**MONTGOMERY COUNTY HISTORIC PRESERVATION COMMISSION**  
**STAFF REPORT**

<b>Address:</b>	7054 Carroll Avenue, Takoma Park	<b>Meeting Date:</b>	3/11/2020
<b>Resource:</b>	Contributing Resource (Takoma Park Historic District)	<b>Report Date:</b>	3/4/2020
<b>Applicant:</b>	Sam and Bobbi Kittner (Rick Vitullo, Architect)	<b>Public Notice:</b>	2/26/2020
<b>Review:</b>	HAWP	<b>Tax Credit:</b>	No
<b>Case Number:</b>	37/03-19CC REVISION	<b>Staff:</b>	Michael Kyne
<b>PROPOSAL:</b>	Egress stairs

## Rear Stair Addition for:

# 7054 Carroll Avenue

A-2

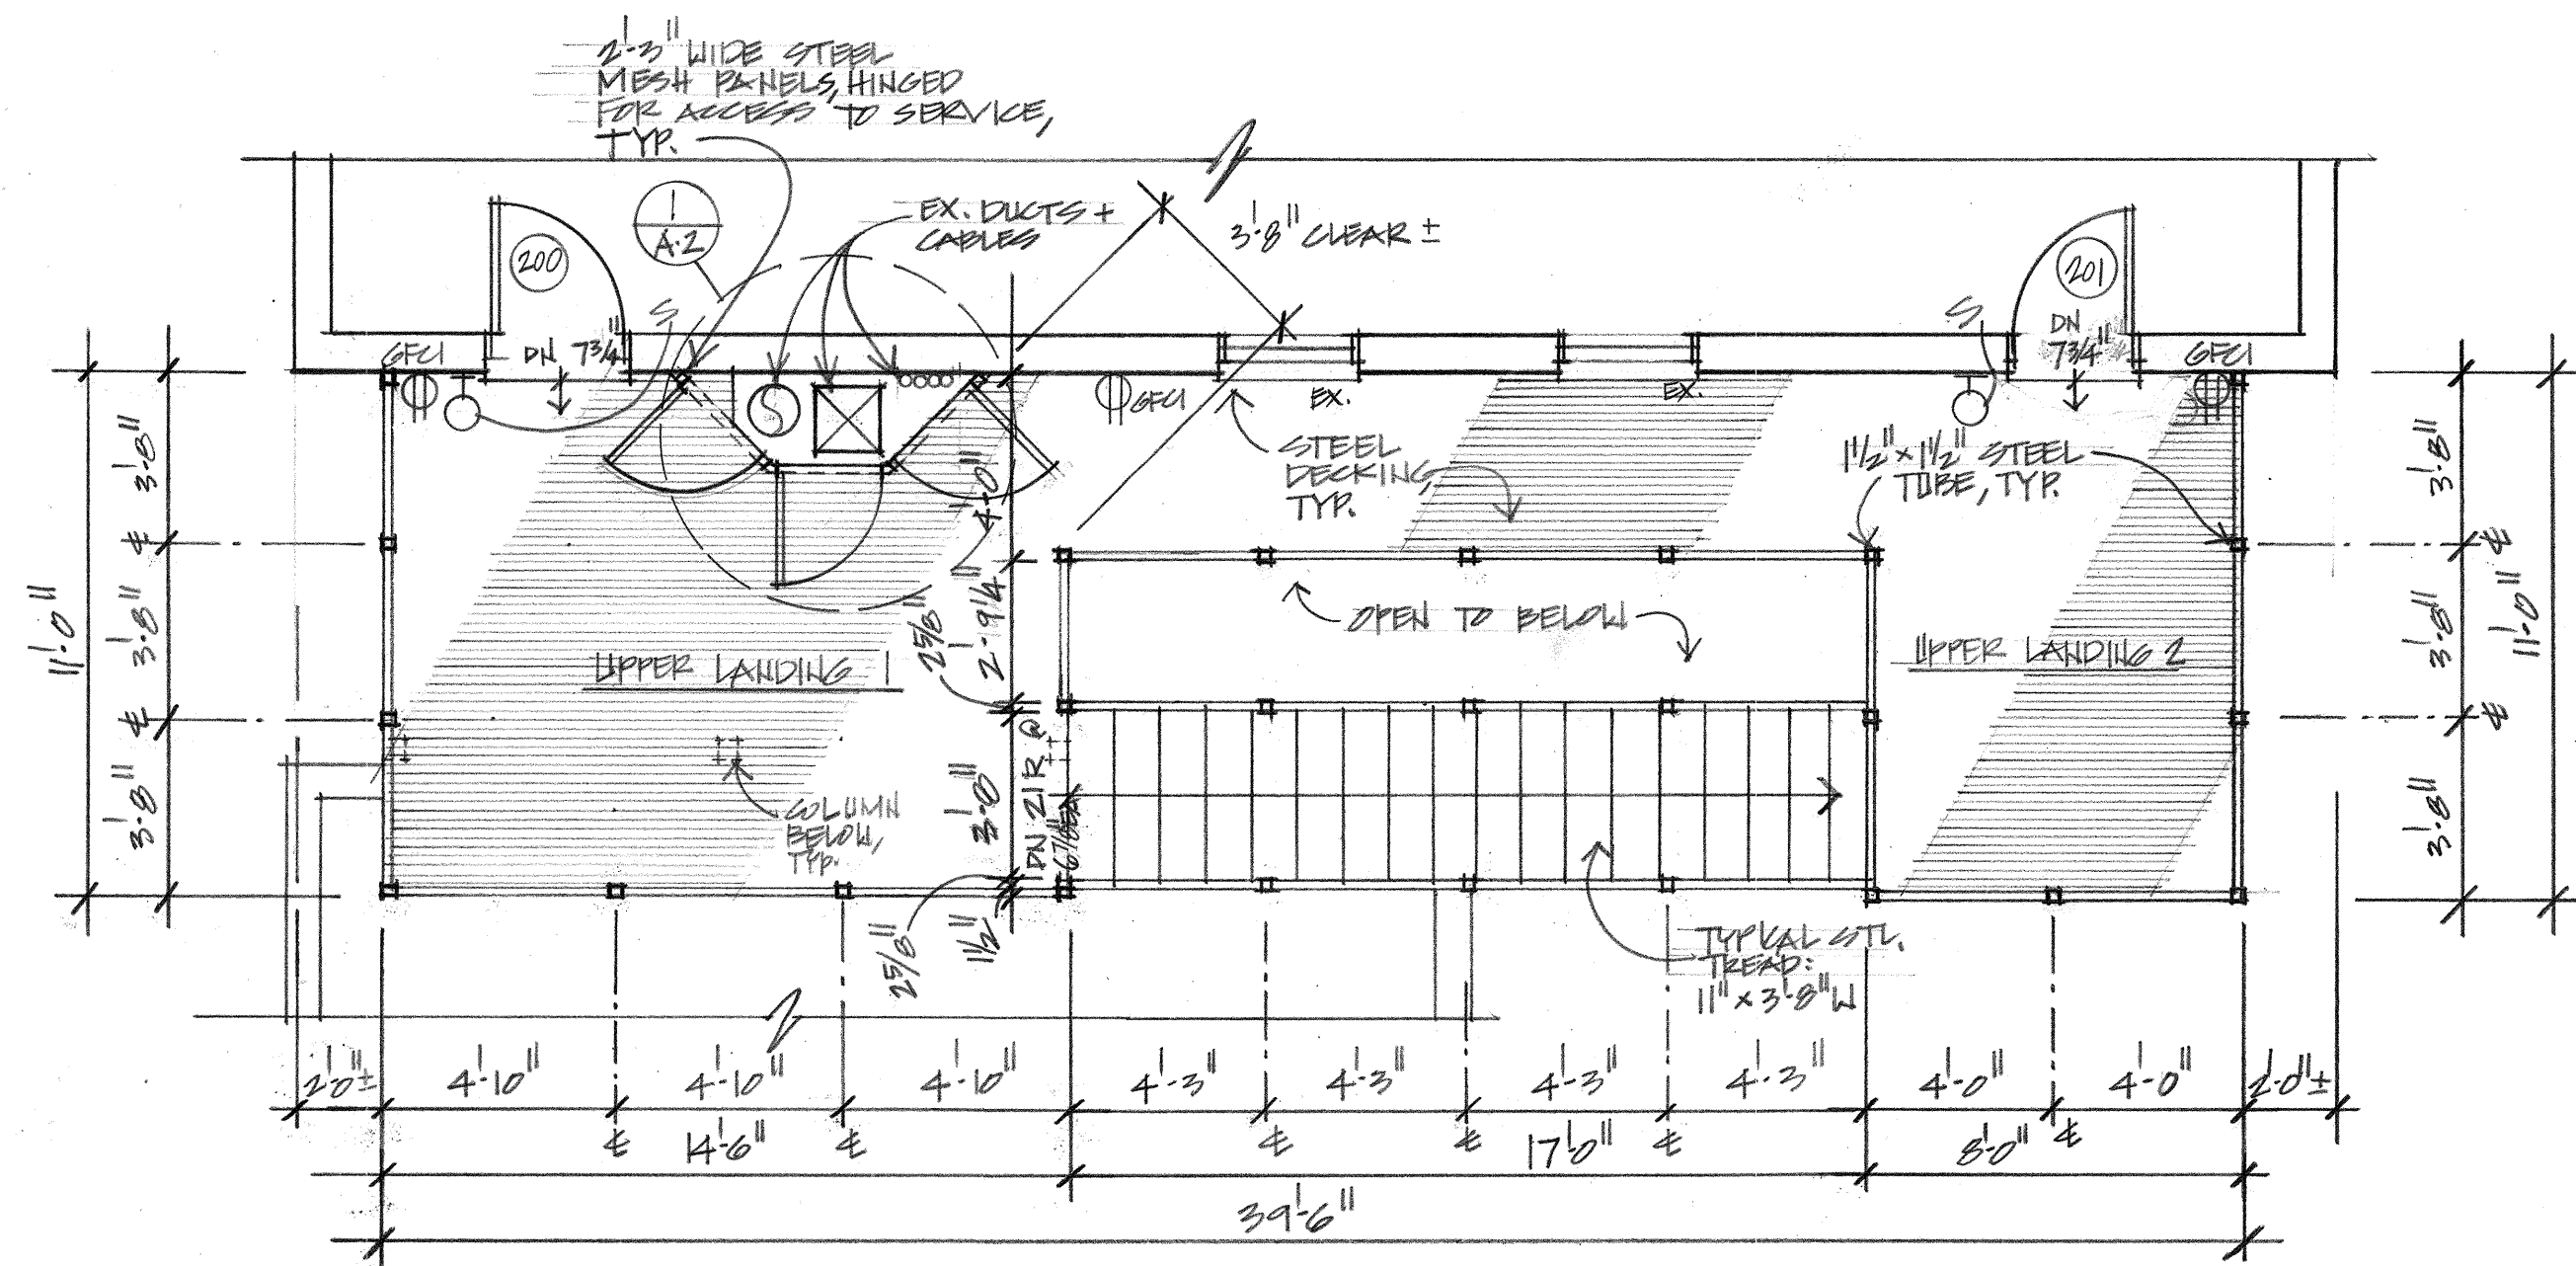
- ½” steel balusters are proposed in place of the previously approved wire mesh/cloth safety screening.
- Diamond patterned steel plate flooring is proposed in place of the previously approved open steel grate flooring.

Due to code requirements, the applicants have revised their application to propose diamond patterned steel plate flooring in place of the previously approved open steel grate flooring. Additionally, the applicants have revised their application to propose ½" steel balusters in place of the previously approved wire mesh/cloth safety screening for all landings and stairs, due to cost considerations. As revised, the previously approved wire mesh/cloth safety screening will be retained at the west side of the fire escape to serve as a plant trellis. It will be also be retained as screening for the vertical duct at the rear of the building.

1. **Flooring:** We had originally desired to have steel open grating for all of the horizontal floor surfaces, including the stair treads. Upon meeting with county code officials however we were told that that would not be code compliant. Only diamond patterned steel plate is compliant, which is what we are now using. (see attachment).
2. **Railings:** Because of availability of large quantities of material, and the familiarity of using this material by the local fabricator, the labor and material cost for using steel mesh was prohibitive to use everywhere. So, we had to eliminate the steel mesh at all of the landing and stair railings, except we did keep it at the west side as a planting "scaffolding" and as the vertical duct screening material. We have proposed using standard vertical ½" x ½" steel balusters at 4" o.c. for all landings and stairs.

NOTE:  
ALL TREADS ARE PRE-FAB STEEL 1/8" THICK  
(3' 8" WIDE) DIAMOND PLATE (FS INDUSTRIES)
